# Technical Service Information

## **FORD CD4E INTERMITTENT TROUBLE CODE 628 OR P0741**

Figure 1

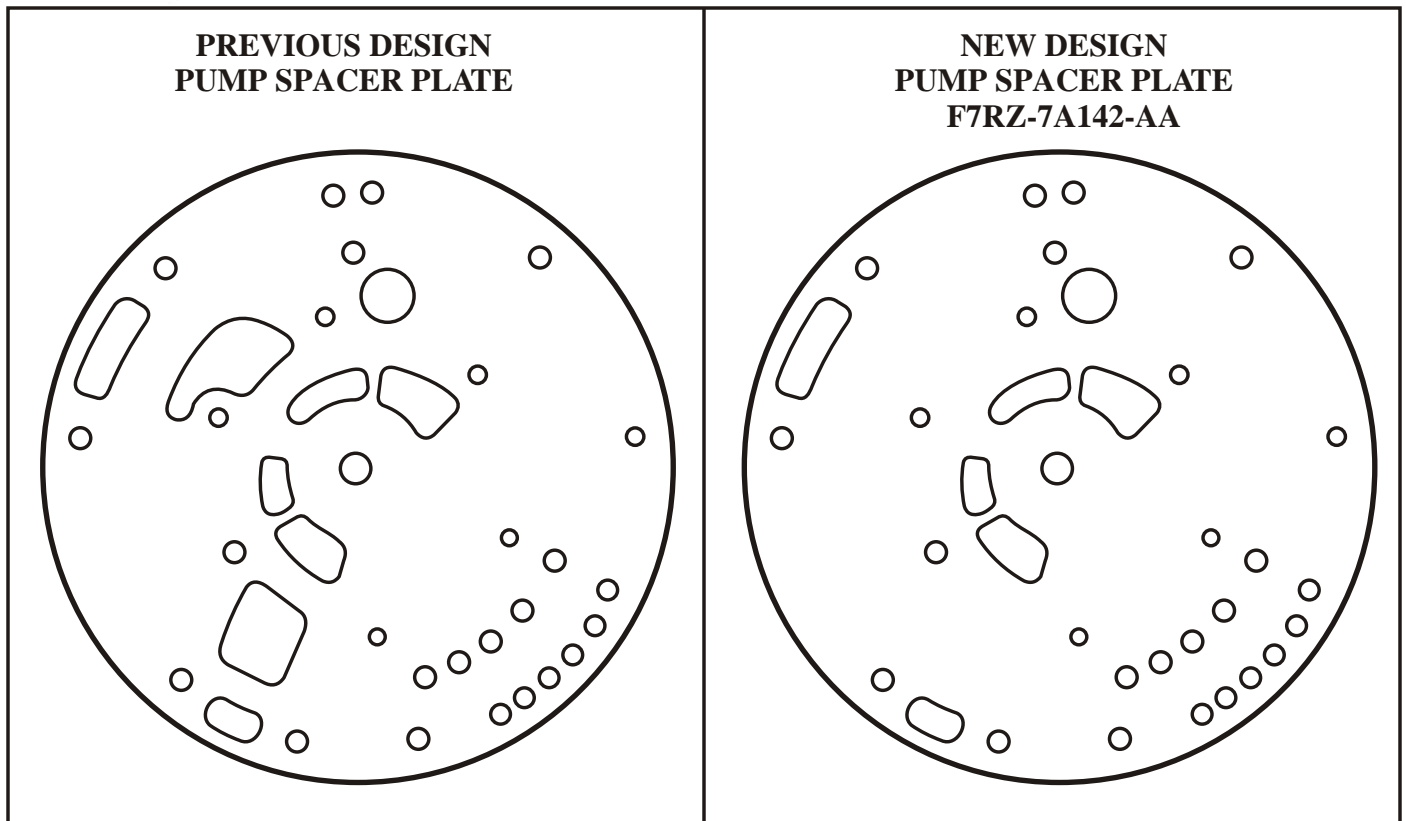
PUMP SPACER PLATE - New design level has two less holes, as shown in Figure 1.

Figure 2

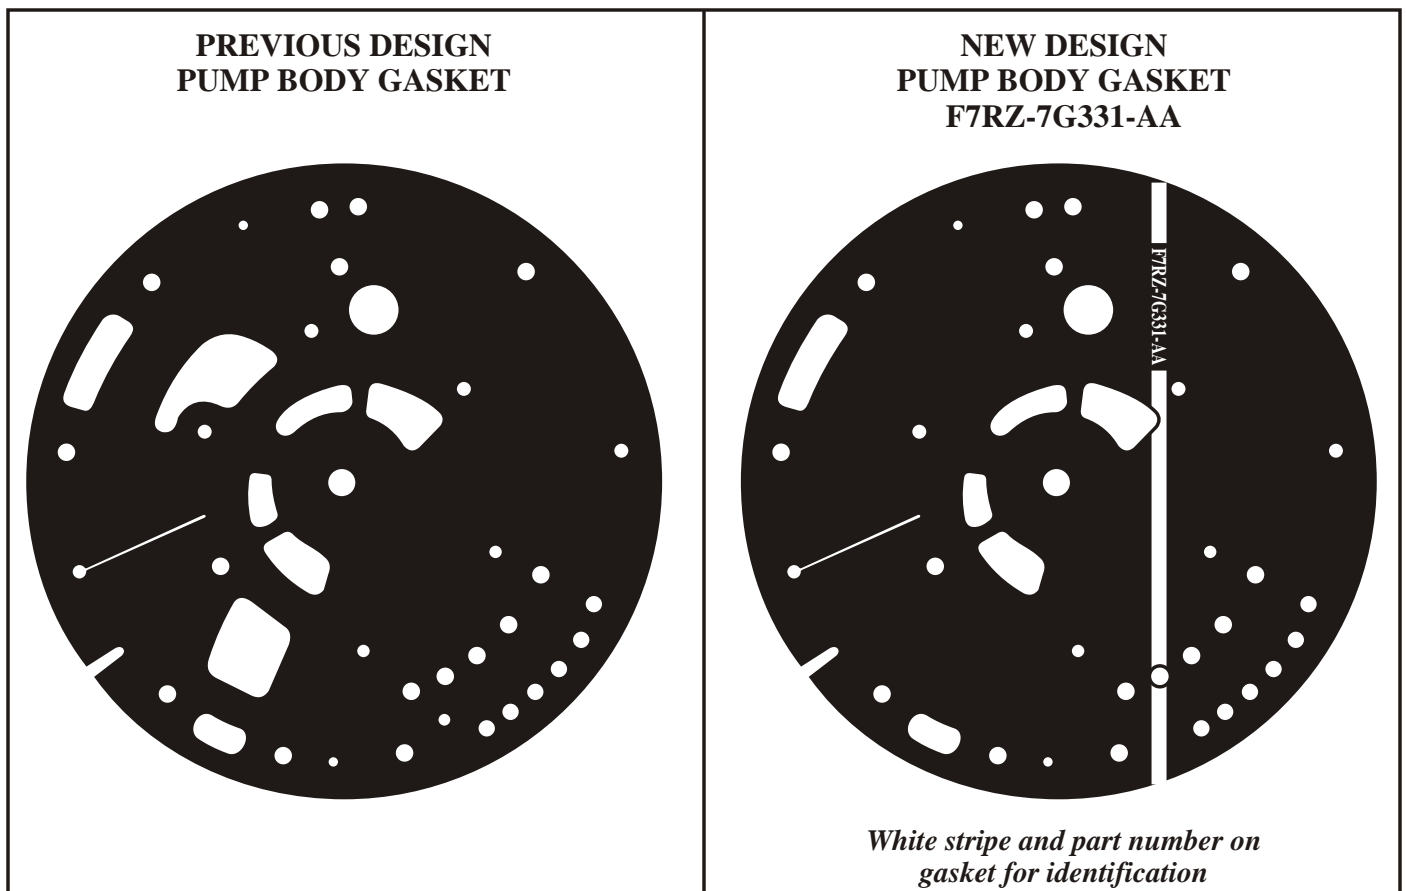
PUMP BODY GASKET - New design level has two less holes and is identified with a White stripe and part number on the gasket, as shown in Figure 2.

Figure 3

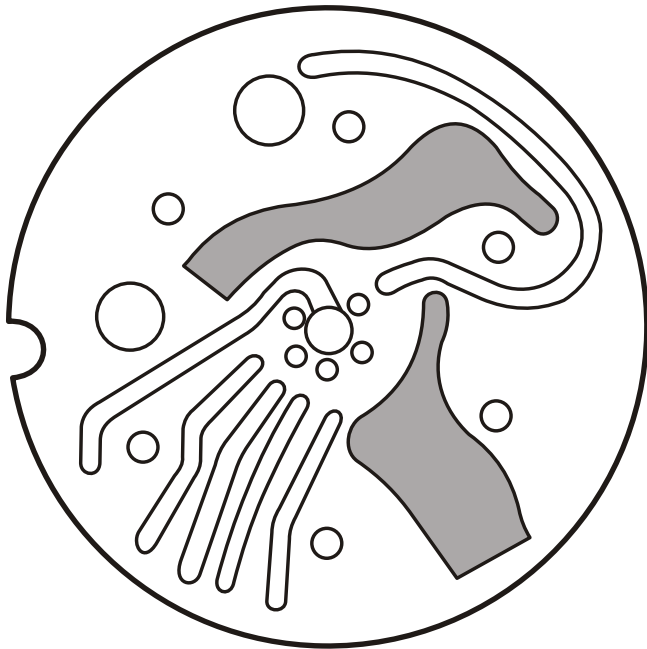
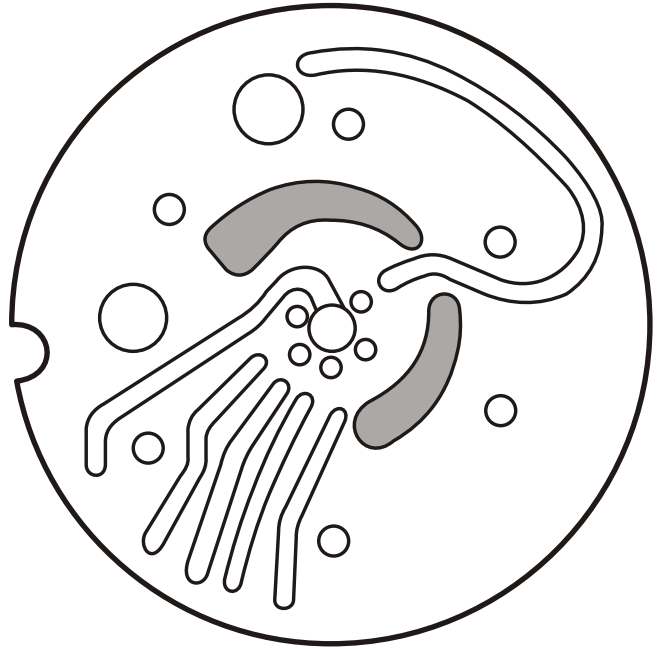
PUMP SUPPORT - New design level has different cavities and we have highlighted the cavities that are different for identification purposes, as shown in Figure 3.
